HINCKLEY NATIONAL RAIL FREIGHT INTERCHANGE – LAND WEST OF STONEY STANTON

WRITTEN REPRESENTATIONS

UPDATED REVIEW OF DCO TRANSPORT ASSESSMENT

Figure 1

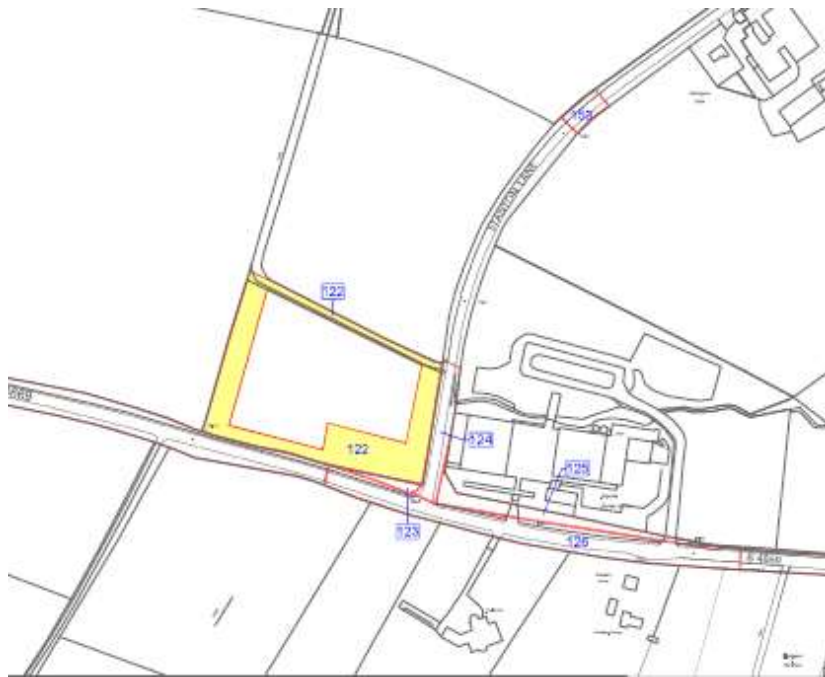
- 4.1. A large area of the Site adjacent to the highway works at Junction 19 – B4669/Stanton Lane is shown shaded yellow at Figure 1 and is included within the DCO land. It is owned by Ms Taylor. From a review of the DCO application documents, it is unclear why that is the case when the only works in the area are new traffic signals at the junction and some minor works on the B4669 Hinckley Road.
- 4.2. Reference is made within Schedule 10 of the draft DCO to a “Construction compound and laydown area in connection with the works on the B4669 Hinckley Road and the alterations to the junction at Hinckley Road and Stanton Lane including access.”
- 4.3. However, it is not clear why the land shaded yellow has been drawn that way. It is excessive and excludes part of the Site in the middle which is effectively isolated from the remainder of the landowner’s interest. This is illogical.

- 4.4. The Statement of Reasons is also silent on why this land is included within the draft DCO and we see no justification for locating a construction compound there whilst there is a significant amount of space within the main body of the HNRFI site that could easily be utilised for such purposes.
- 4.5. Any construction compound in that area could sterilise the development of the Site on that land for a significant period of time, which would be unacceptable to the Consortium and Ms Taylor.

- 4.6. In short:
 - 4.6.1. There is no compelling case for the temporary acquisition and sterilisation of this land; and
 - 4.6.2. There are reasonable alternatives to the use of this land as a construction compound that the applicant has failed to adequately explore.
